To: Kristopher Byrd, Well Construction and Compliance Section Manager
From: Travis Kelly, Well Construction Compliance Coordinator
Subject: Review of Water Right Application G-19072
Date: February 25, 2022

Groundwater Application Review Summary Form

Application # G- 19072

TO: Water Rights Section Date 2/17/2022
 FROM: Groundwater Section Halley Schibel/Travis Brown
 Reviewer's Name
 SUBJECT: Application G- 19072 Supersedes review of _____
 Date of Review(s)

Water-Level Measurements in Nearby Wells

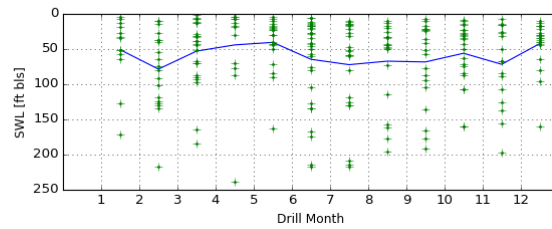
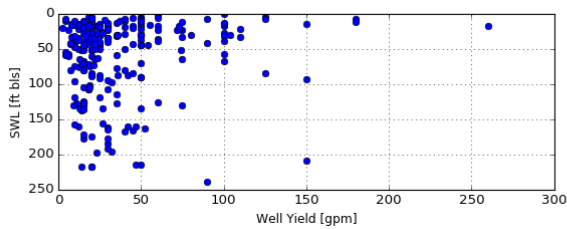
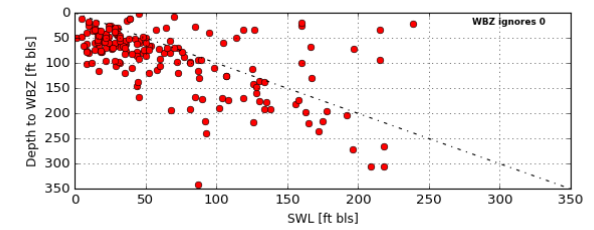
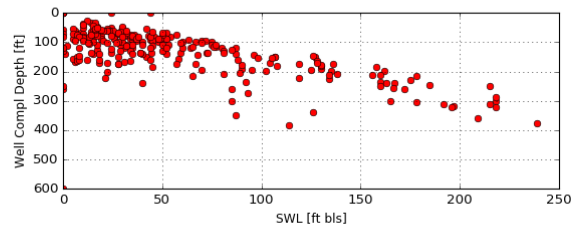
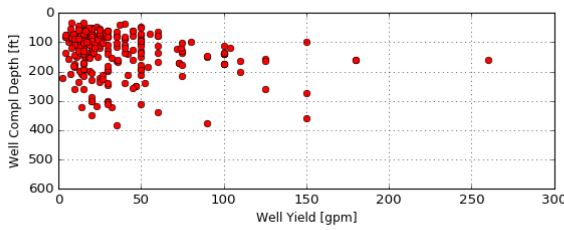
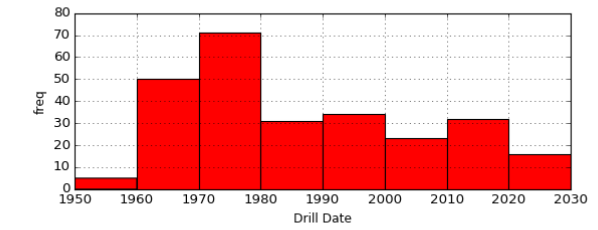
Nearby observation wells include wells on permits with static water level reporting conditions, which have measurements on record since the early 2010's. These wells do not appear to show excessive, area-wide declines, although CLAC 66847 and CLAC 66853 appear to show a slight decline over the last four years.

Theis Drawdown and Recovery at $r = 580$ ft From Pumping Well

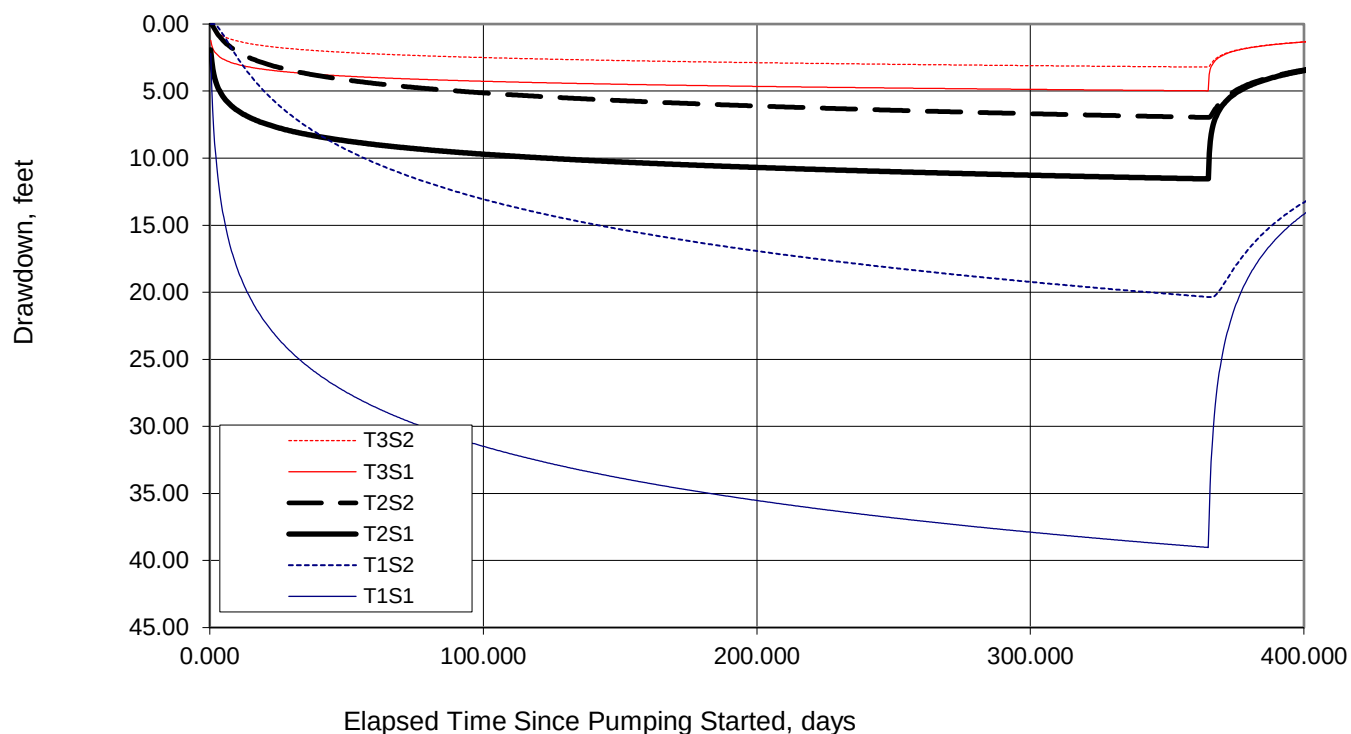
The proposed POAs are located in the Central Willamette Valley and will produce from strath terrace deposits (Madin, 2004) consisting of sand and gravel (the Willamette Aquifer described by Gannett and Caldwell, 1998), which overlies fine-grained distal alluvial fan and low gradient stream deposits locally separated by thin layers of sand and fine gravel (Willamette Confining Unit). The Willamette Aquifer is estimated to be ~100 ft thick in this location. The majority of wells in the immediate vicinity draw water from the Willamette Aquifer. The requested rate (0.056 cfs) is well within the range of reported yields for water wells in this area (see attached well statistics) and is unlikely to injure the closest neighboring well, CLAC 5188 (see attached Theis analysis), which is ~580 ft to the northeast.

In order to protect the groundwater resource and neighboring users, the conditions specified in B1(d)ii and B2(c), above, are recommended for any permit issued pursuant to this application.
